HEARINGS COMMITTEE AGENDA

1 RESOURCE CONSENT APPLICATION – LUC-2022-215 and SUB-2022-80, 30 TUI STREET, DUNEDIN

Report from Lianne Darby

Appendix 2: Subdivision Scheme Plan

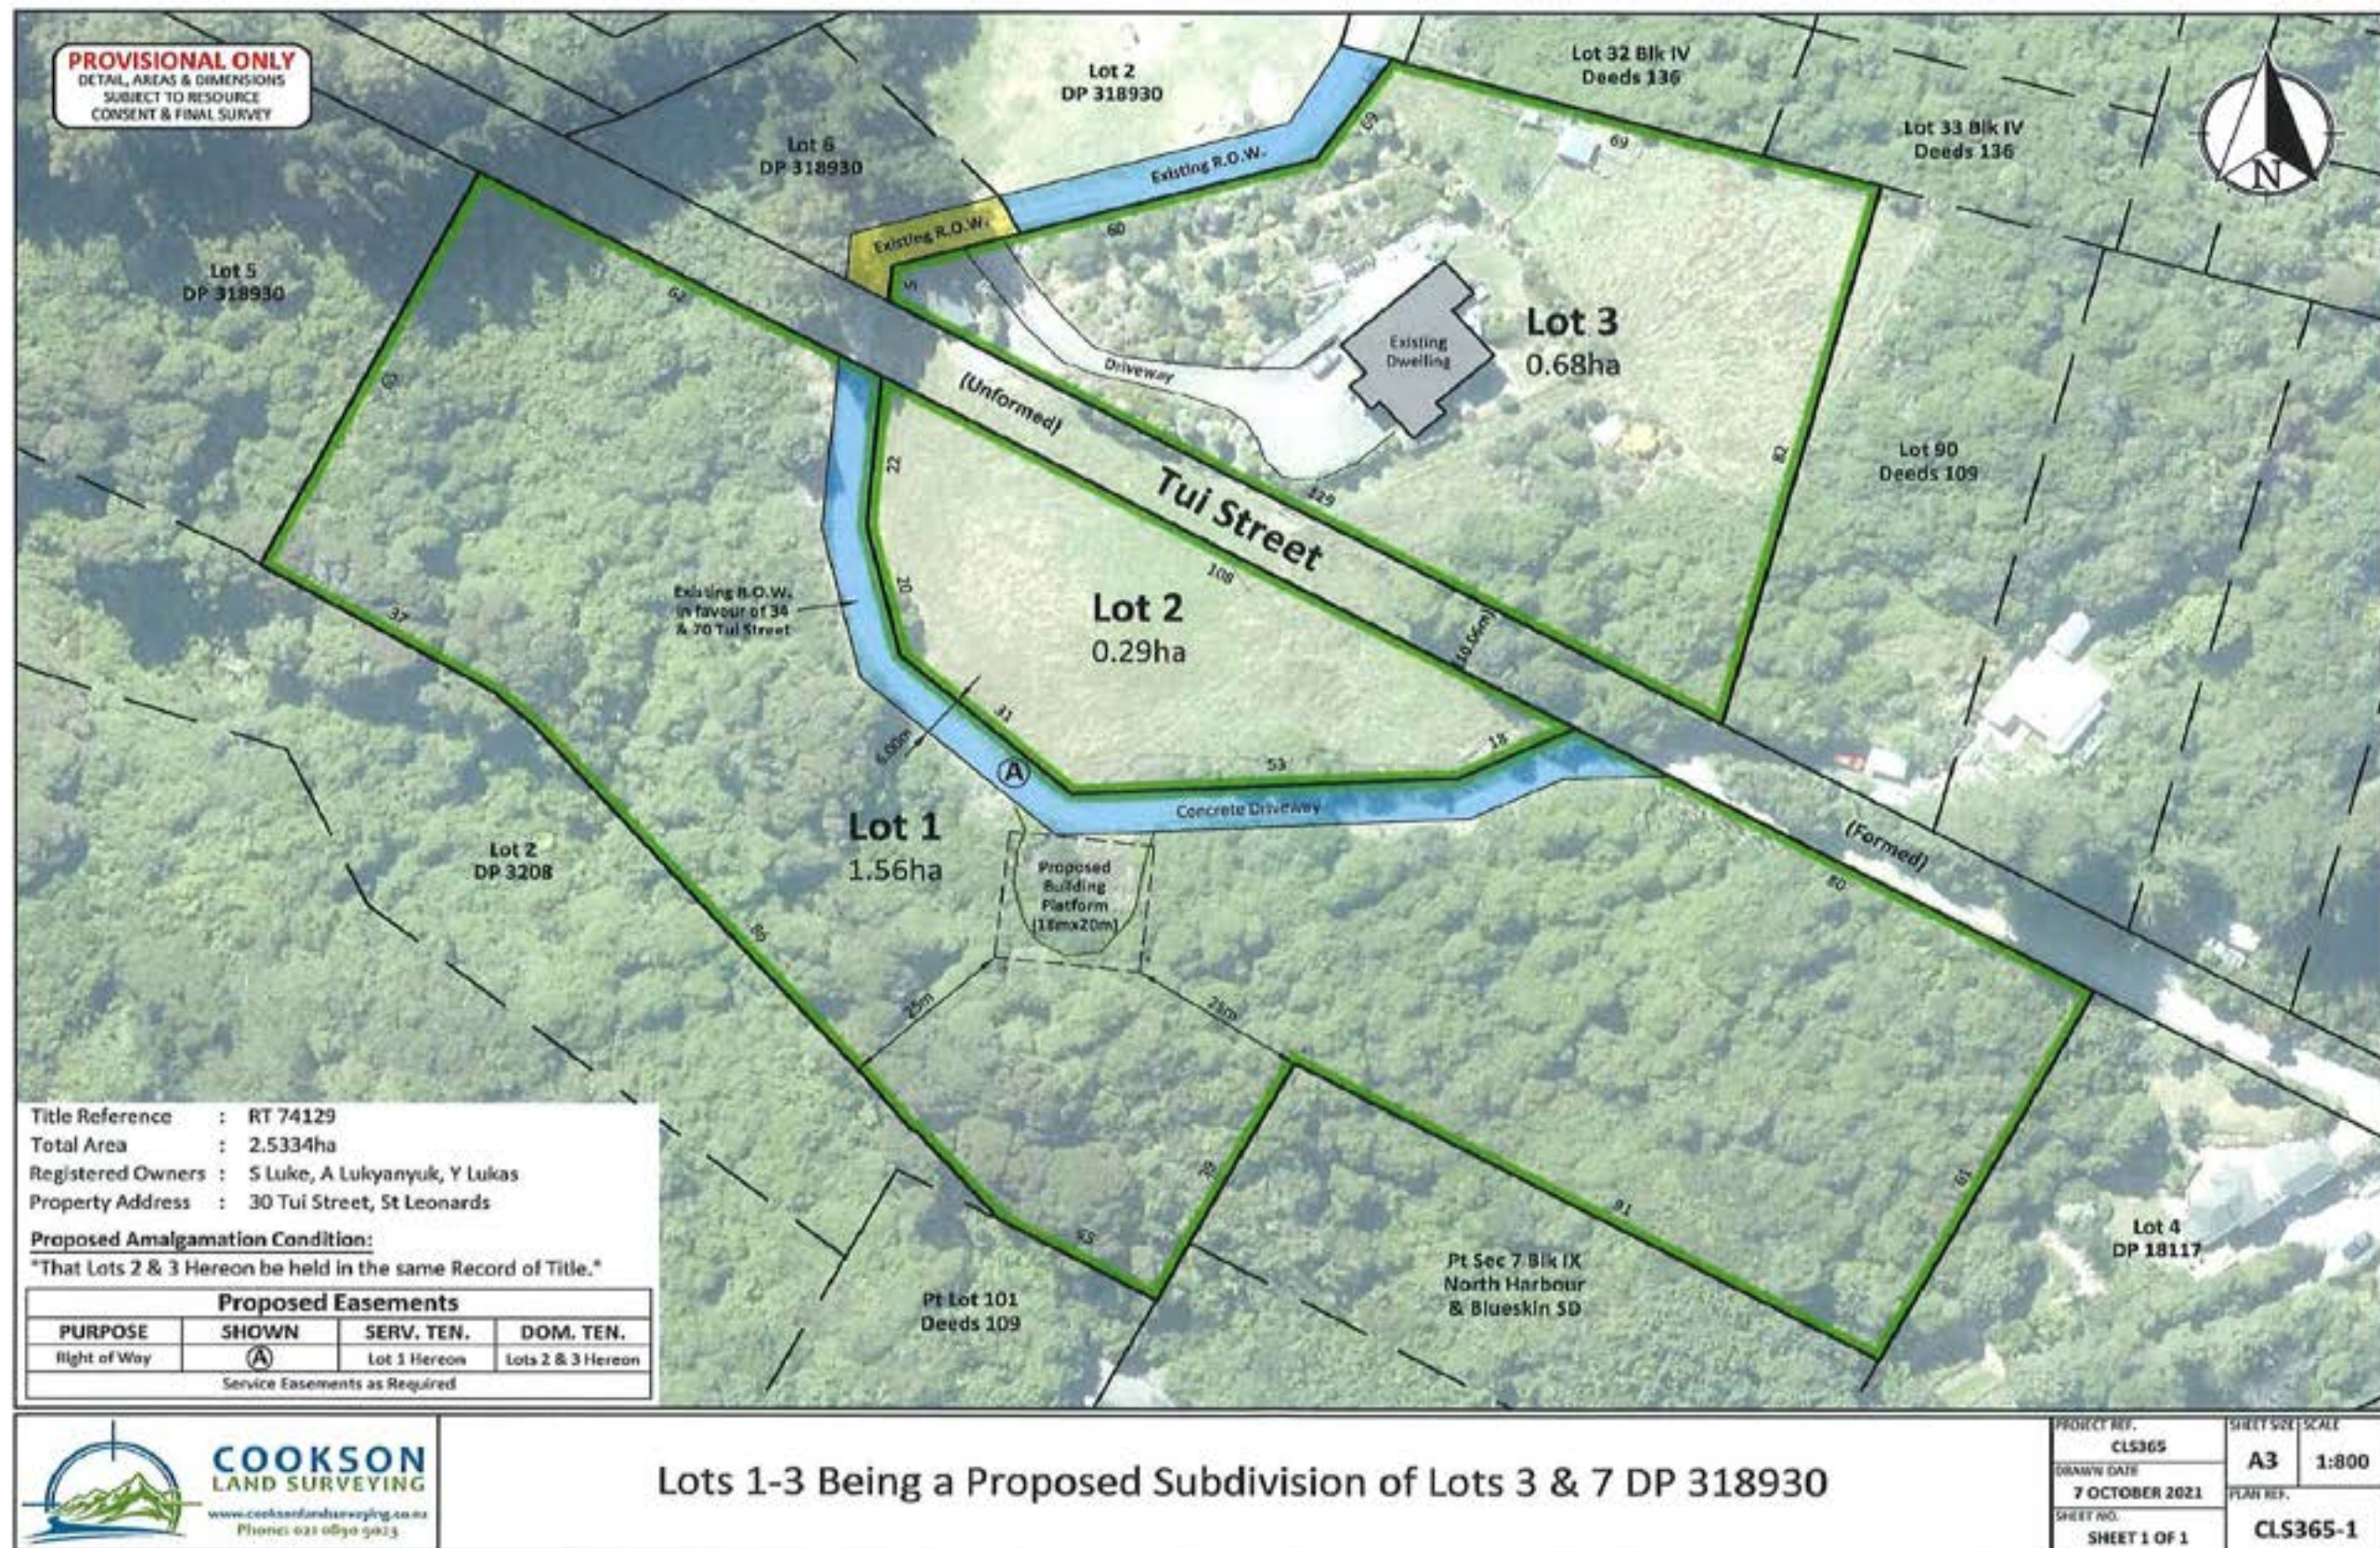
- [70] Currently, the shared driveway has a formed width of approximately 3.5m and provides access to three dwellings which is acceptable. However, the applicant proposes to construct a new dwelling on proposed Lot 1, bringing the total number of users to four. This will require the driveway to have a minimum formed width of 5.0m. The widening of the driveway is not proposed by the applicant and is therefore a breach of the aforementioned rule. The Graduate Planner – Transport considers that the effects of this breach can be considered less than minor, given that this is a pre-existing situation which would only create one additional user. It is noted that in the event of future development, this may be re-assessed and the driveway may be required to be re-formed.

- [79] The proposed landscape building platform for Lot 1 is shown as being as close as 6.0m to the new boundary shared with Lot 2, therefore contravening the boundary setback requirement by up to 4.0m. It is possible that a new dwelling constructed within the landscape building platform will be fully compliant with a 10.0m setback requirement, but the authorising of the proposed building platform will allow a setback contravention of up to 4.0m. There is also a Proposed Plan requirement for buildings to be setback at least 1.0m from a formed driveway serving more than two residential units. It is expected that the future development of Lot 1 will comply with this requirement on the basis that the legal right of way is wider than the existing formation and there appears to be at least 1.0m separation between the edge of the existing driveway and the right of way boundary.

- b) *That a right of way over the existing access through Lot 1 must be duly created or reserved in favour of Lot 2/3 and must be shown on the survey plan in a Memorandum of Easements. The right of way must have a minimum legal width of 6.0m and the southern boundary must be at least 1.0m from the formation of the existing access.*
